Access Compliance Report

Public Rights-of-Way

(Pedestrian Signals)

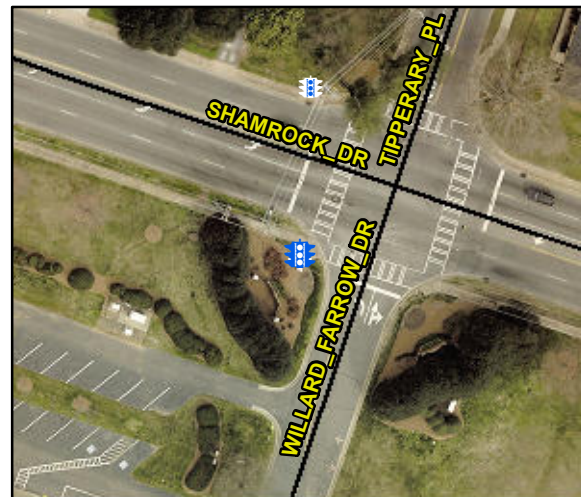
Surveyor Notes: TEXT HT 1/2

Yes	B 1 Clear Xing Direction?	ClearlyMarked	N/A	B 2 Clear Xing Direction?	N/A
	B 1 Crossing Direction	To NE		B 2 Crossing Direction	N/A
Yes	B 1 DistanceTo XWalk (in)	0.0	N/A	B 2 DistanceTo XWalk (in)	N/A
No	B 1 DistanceTo Curb (in)	115.0	N/A	B 2 DistanceTo Curb (in)	N/A
Yes	B 1 Diameter (in)	2.0	N/A	B 2 Diameter (in)	N/A

Possible Solutions: Replace Signal Push Button With APS Button on New Post. Remove & Replace Sign.

PROW/ADA: R410.6, TMUTCD 4e.08, R404.1, R404.7.3
